Schaumburg Township District Library

Furniture bid

Addendum #2

2/6/23

Dual-Sided Bases with Rail

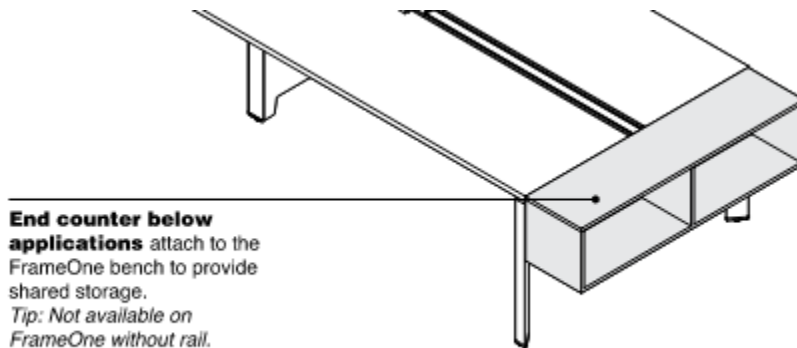
For the Steelcase T21 in the Local History area, what is the “tall storage end of counter below” mean? We have the end of counter covered, just not sure about the tall storage.

Provide table and extension highlighted below:

Provide end of counter storage flush with top at one end, as image below shows. This appears to be called “Tall Storage” in the spec guide, but the intent is shown below.
